Your ref: Docket No. 52-006
Our ref: DCP/NRC1628

SUBJECT: Transmittal of Responses to AP1000 DSER Open Items

Draft Safety Evaluation Report Open Item Response

Figure 9 – Isometric View: Comparison of AP600 and AP1000 DVI-A Piping System

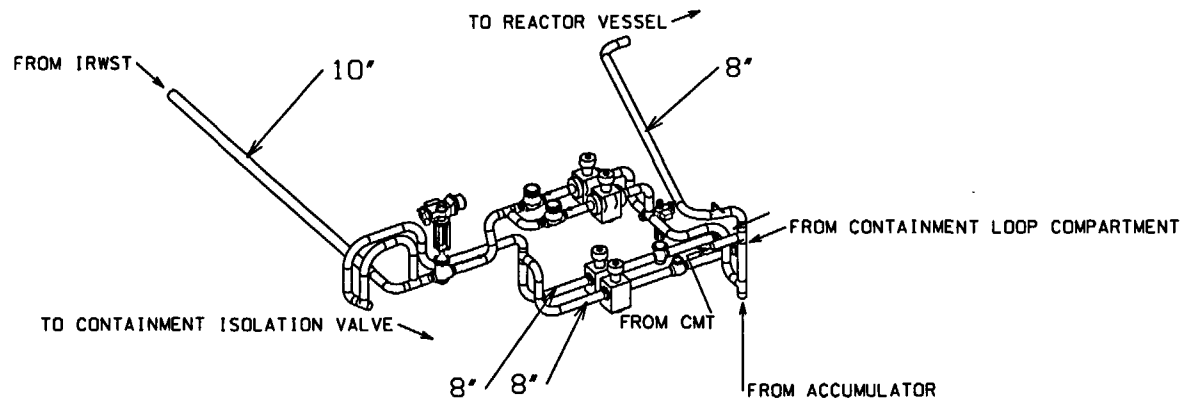
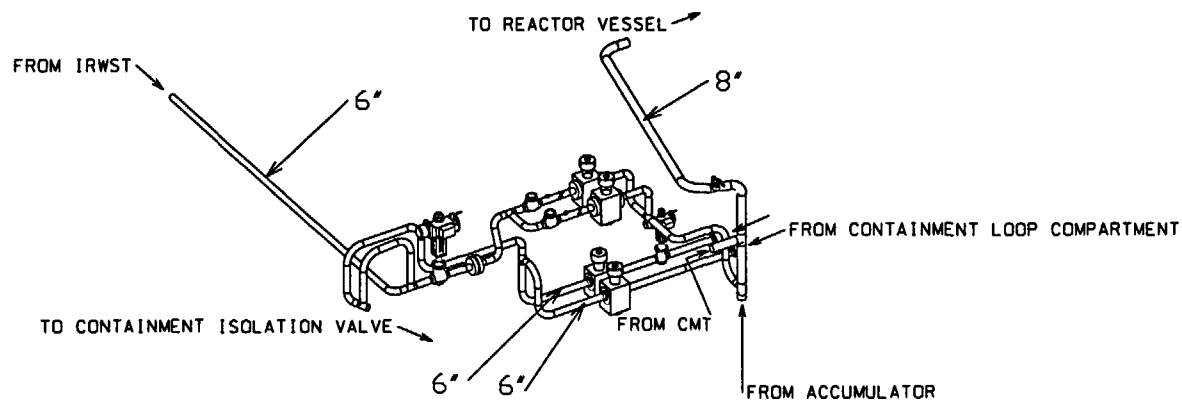
Complexity of piping system - The DVI-A piping system is complex, and was particularly challenging to qualify for the AP600. The AP600 design and analysis of the DVI-A subsystem was performed over several iterations that included perturbations in the piping layout, support configuration, and piping analysis. Figure 9 shows isometric views of both the AP600 and AP1000 DVI-A piping system.

Figure 10 - Bounding Analysis Curve – DVI-A – 8" (316 SS, 537 °F)

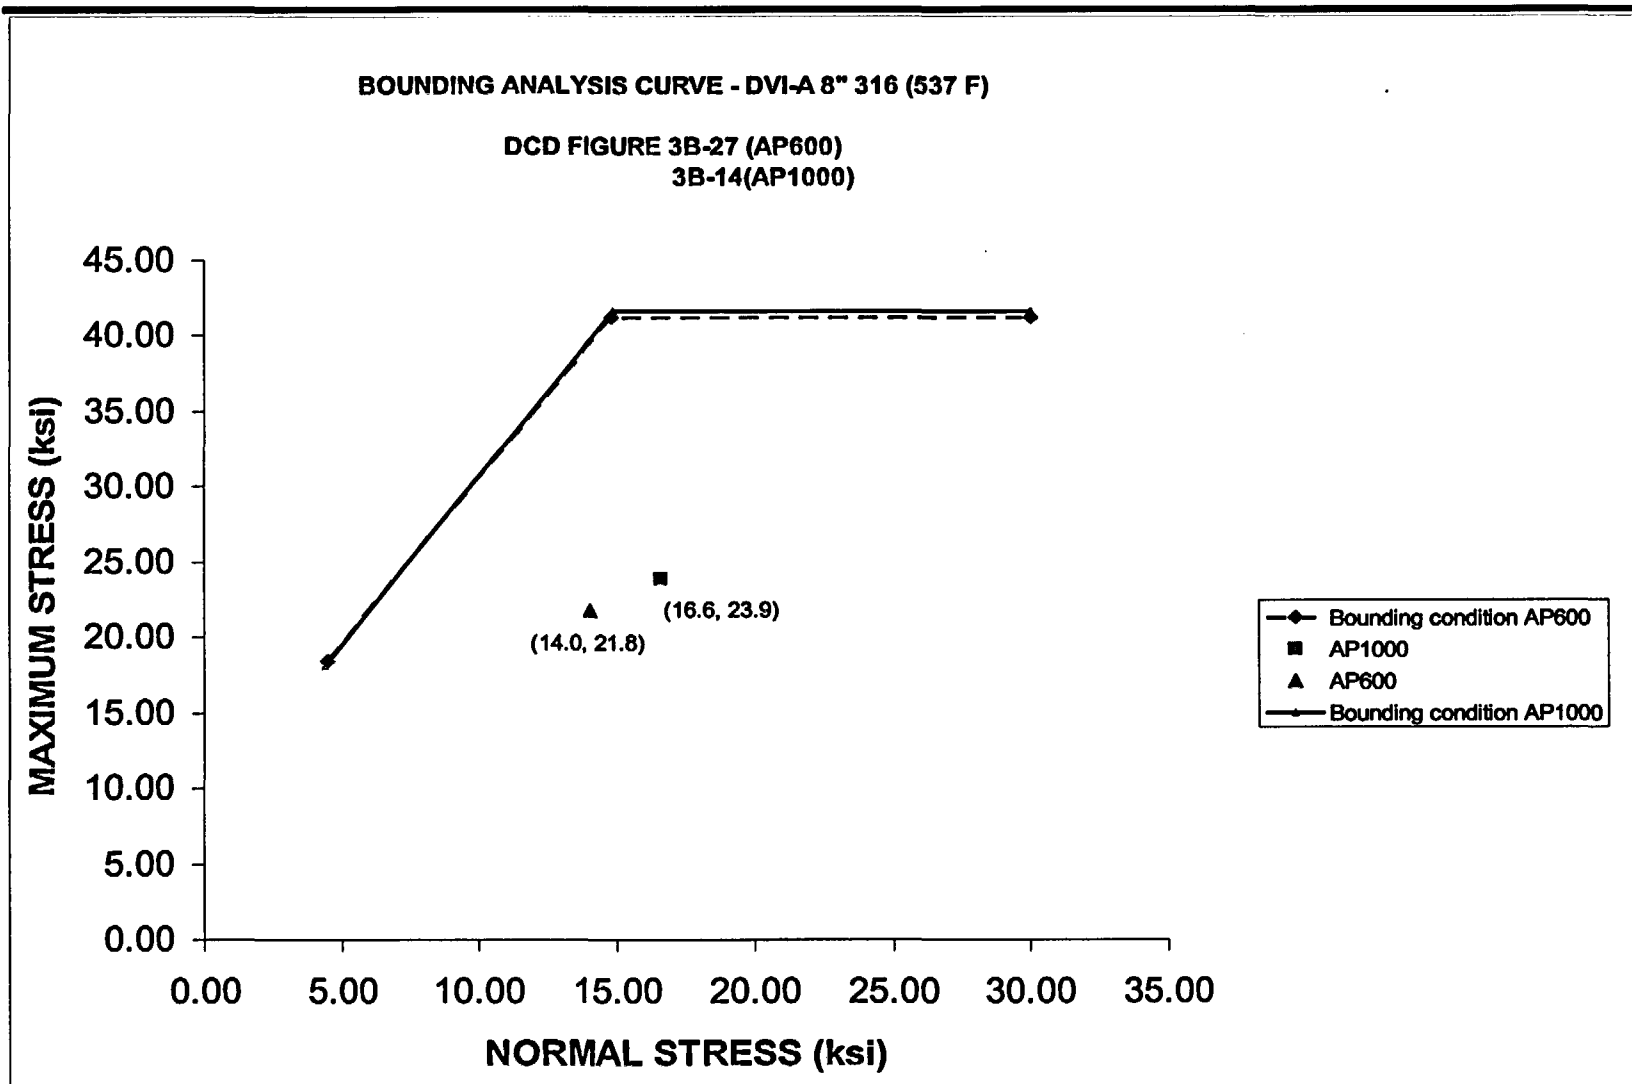
Table 3 Summary of DVI-A Preliminary Piping Stress Analysis Results			
Pipe Segment	Maximum Calculated Stress (ksi)	Bounding Analysis Curve Limit (ksi)	Report Figure
8-inch, 316SS, 537F	23.9	41.6	Fig. 10
8-inch, 316SS, 120F	22.0	44.0	Fig. 11
8-inch, 304	13.8	14.4	Fig. 12
8-inch, Sch 40S	11.7	22.7	Fig. 13
6-inch, RNS	14.5	22.9	Fig. 14
8-inch, PXS	22.3	44.5	Fig. 15

Figure 16 - Bounding Analysis Curve – Primary Loop Hot Leg – 31”

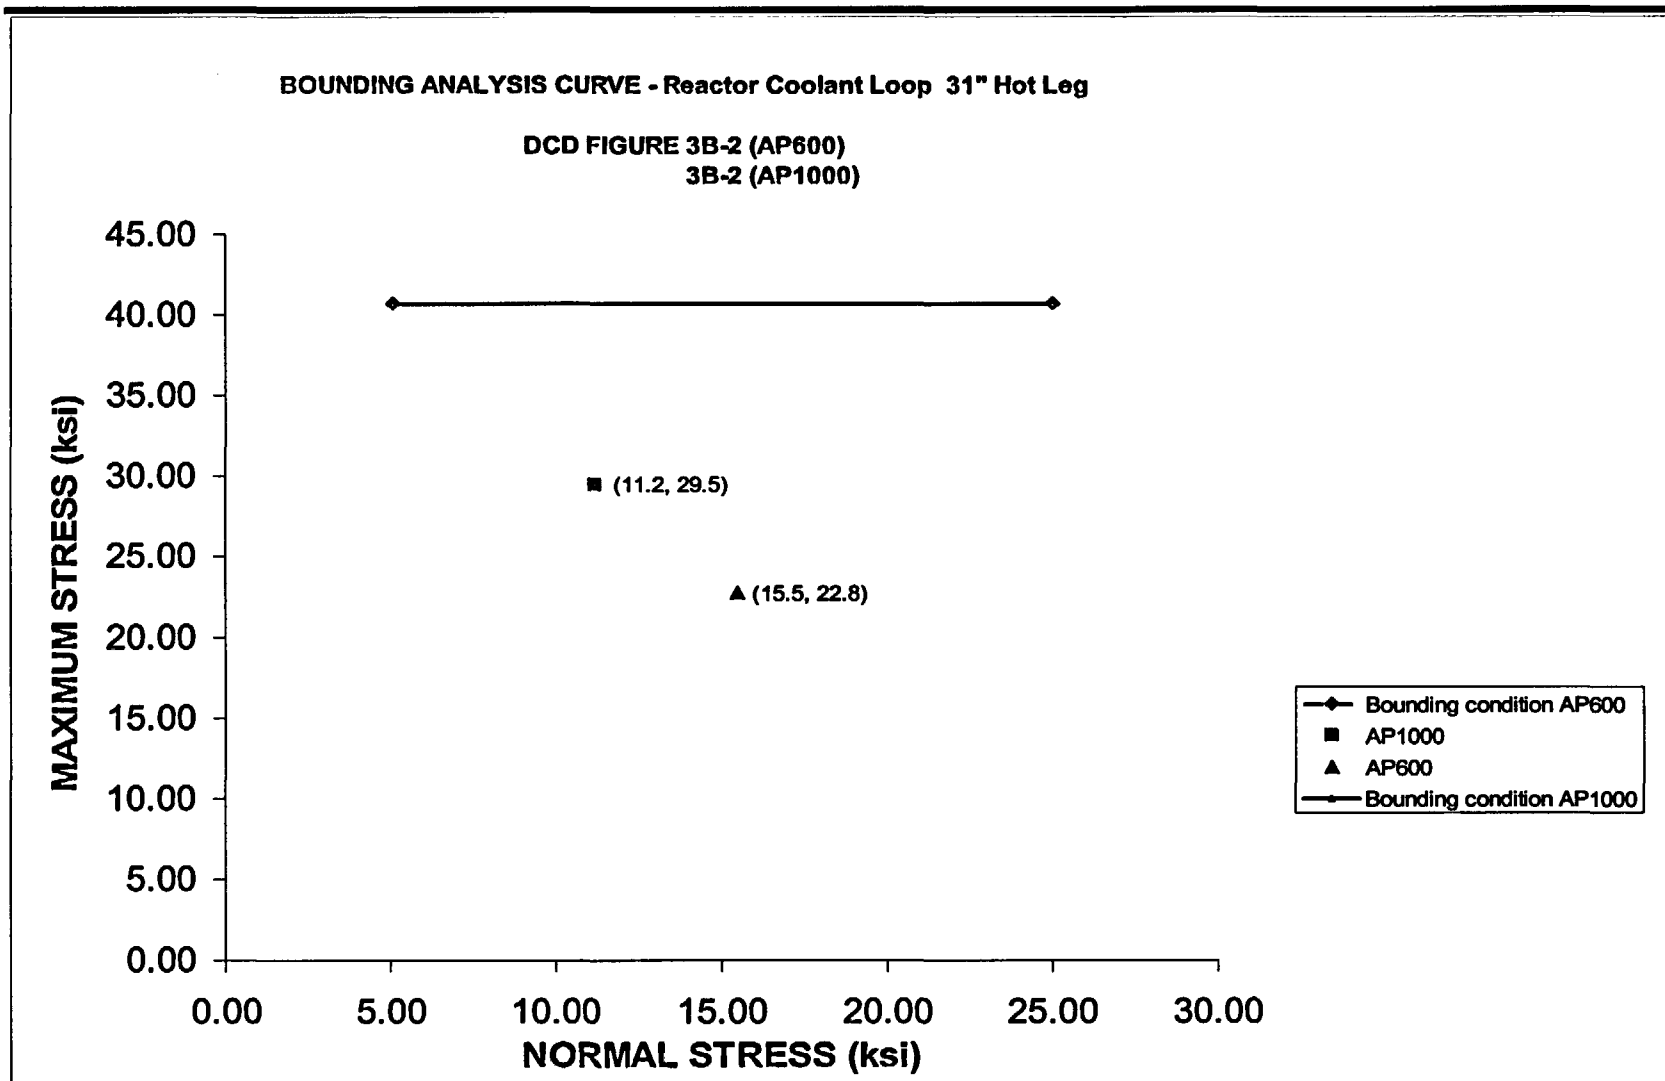
The Hot Leg pipe diameter is the same as AP600. The seismic multiplication factor is 1.74. This includes the affect of the higher elevation of the steam generator upper lateral support. The maximum stress is 29.5 ksi which is less than the BAC stress of 40.7 ksi. Figure 16 shows the BAC and the estimated stresses for the AP1000 plant. Feasibility of LBB for AP1000 is confirmed.

Figure 17 - Bounding Analysis Curve – Primary Loop Cold Leg – 22"

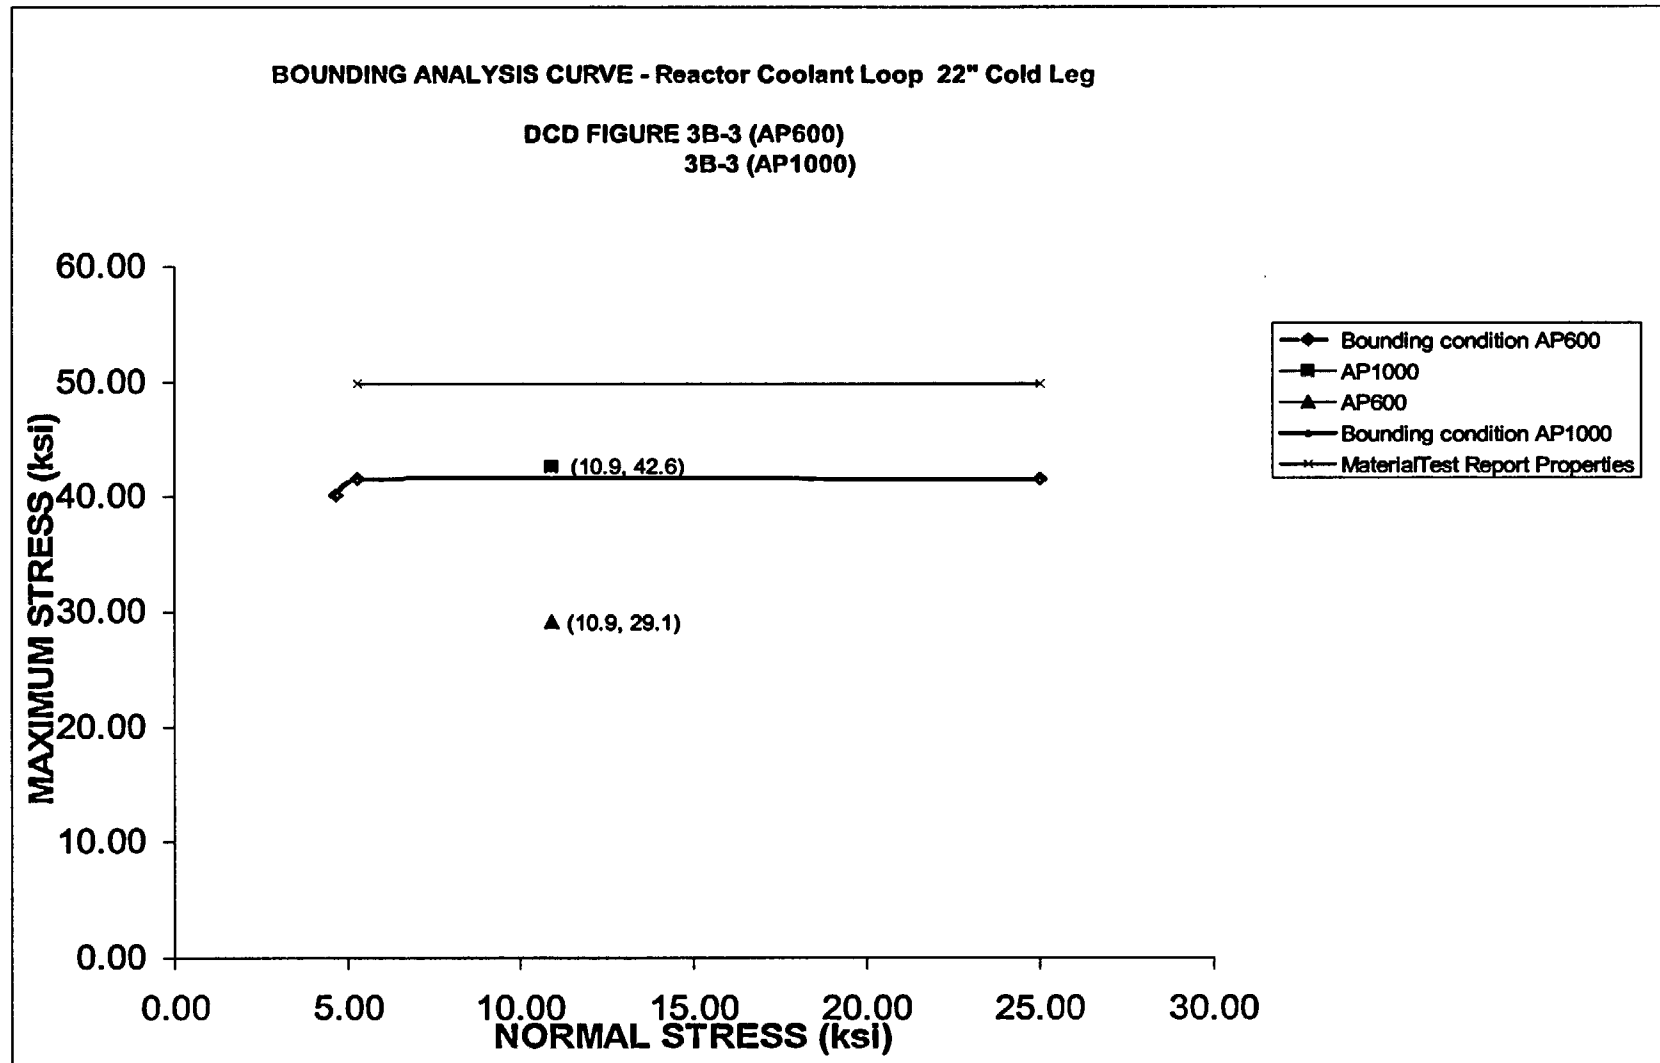
The Cold Leg pipe diameter is the same as AP600. The seismic multiplication factor is 1.74. This includes the affect of the higher elevation of the steam generator upper lateral support. The maximum stress is 42.6 ksi which is lower than the modified BAC stress of 49.9 ksi. Figure 17 shows the BAC and the estimated stresses for the AP1000 plant. Therefore, the feasibility of LBB for AP1000 is confirmed.

Figure 22 - Pressurizer Safety Valve Inlet Pipe Break Protection (Sheet 1 of 2)

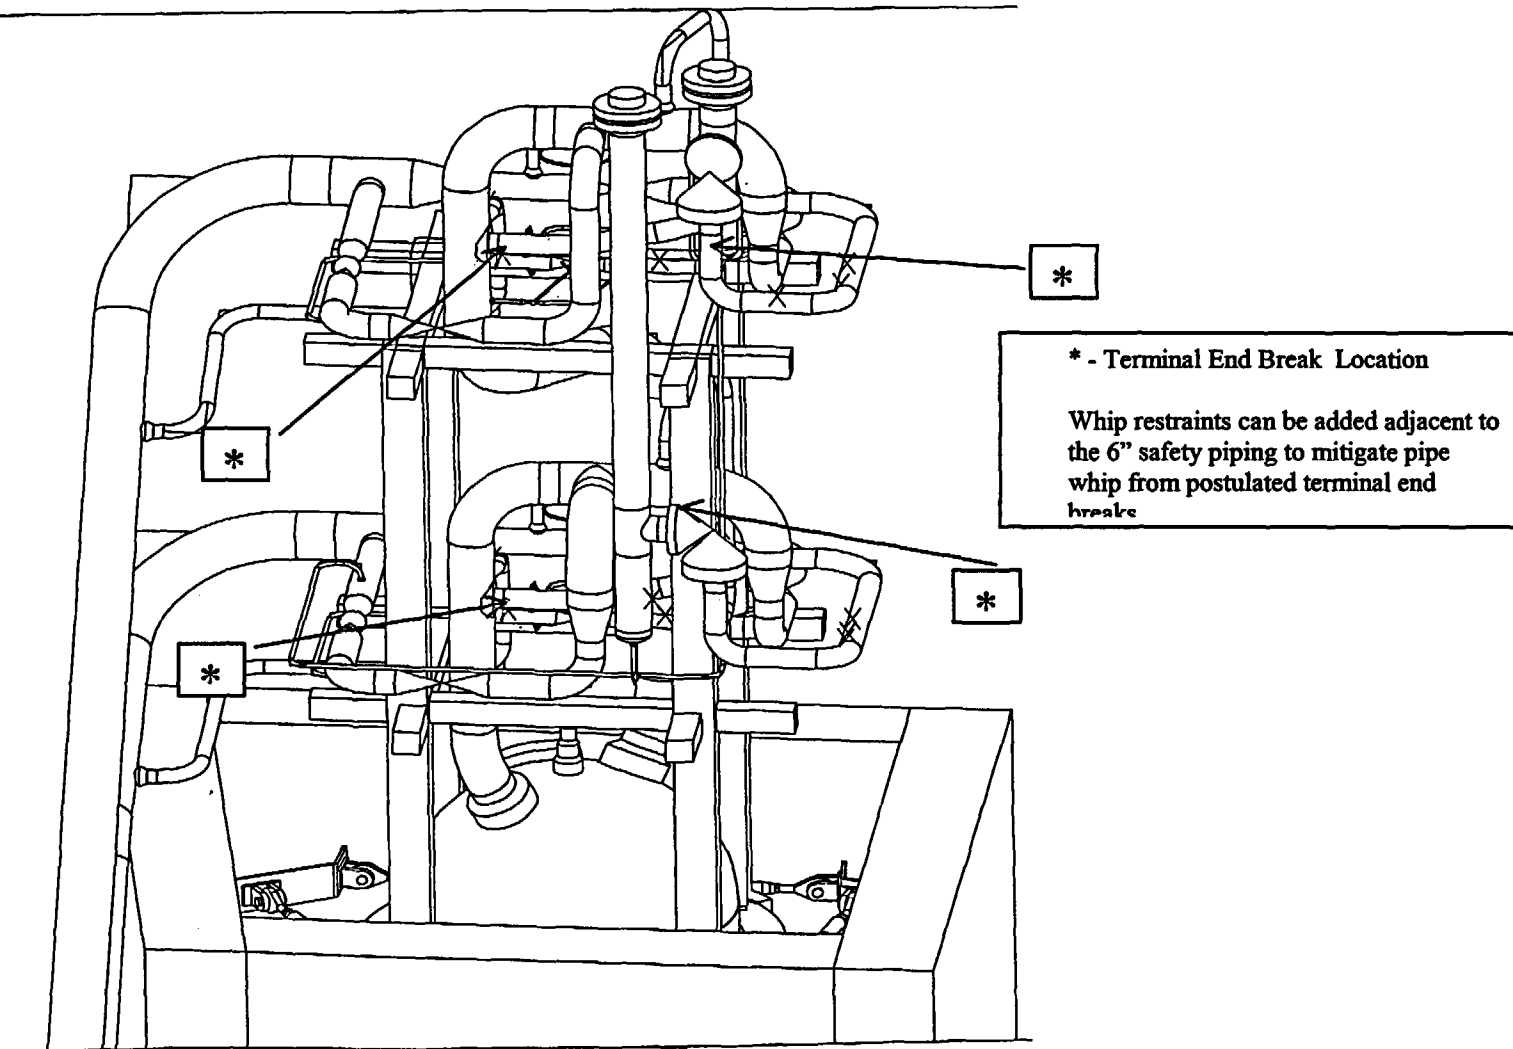
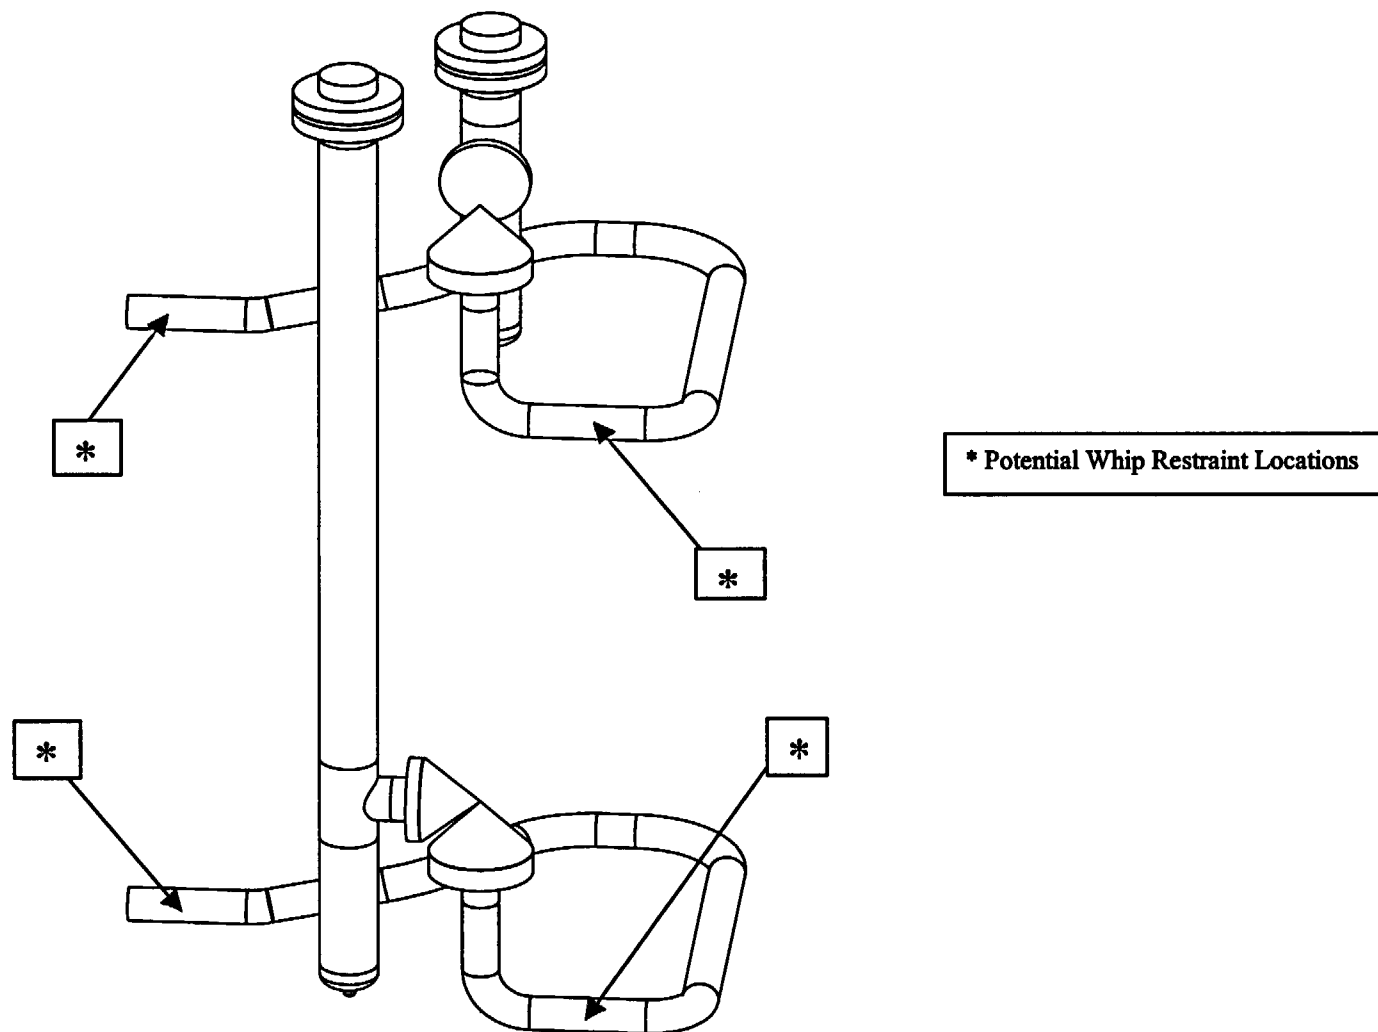
This report summarizes an assessment of applying Leak-Before-Break methodology to the candidate AP1000 plant pipe lines listed in Table 1. Feasibility is demonstrated for the LBB candidate piping systems with one possible exception of the Pressurizer Safety Valve inlet piping (6"). For these two lines, the high energy pipe breaks can be mitigated by the installation of protection devices (whip restraints) as shown at the locations in Figure 22 if required.
